**Sandia Corporation
Albuquerque, New Mexico
October 20, 2008**

**DOE/Sandia Responses to NMED
“Notice of Disapproval: Summary Report for the
Mixed Waste Landfill Monitoring Well Plug and
Abandonment and Installation – Decommissioning of
Groundwater Monitoring Well MWL-BW1 Installation
of Groundwater Monitoring Well MWL-BW2, April,
2008 Sandia National Laboratories, EPA ID#
NM5890110518 HWB-SNL-08-015 ” August 25, 2008**

ATTACHMENT A
LITHOLOGIC LOG

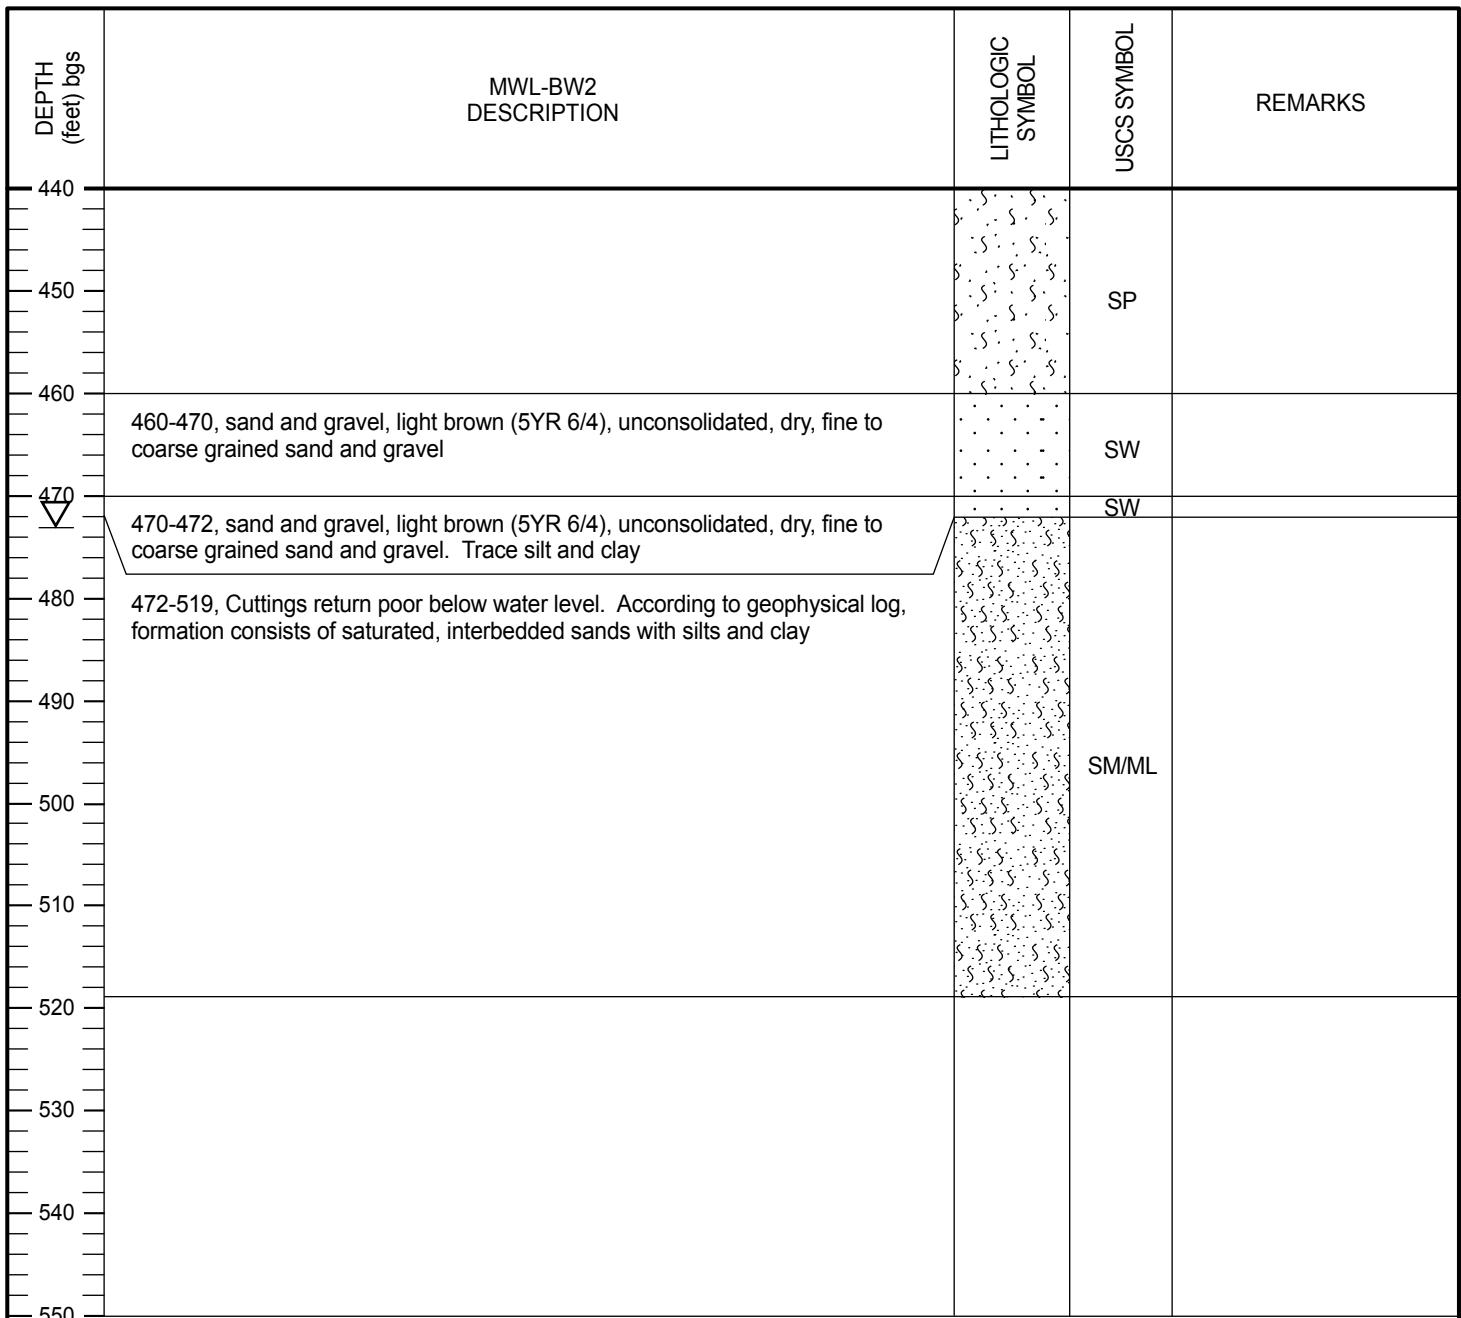
Comment 5: Much of the Combination Lithologic and Geophysical Logs with Well Construction Details for the MWL-BW2 submitted in Attachment C is difficult to read, submit a readable version. Also, submit an electronic version of the geophysical log data, preferably in depth/value spreadsheet format.

Response 5: The lithologic log has been prepared in a different format and is provided as Attachment A. An electronic version of the geophysical data has been provided to the NMED under separate cover.
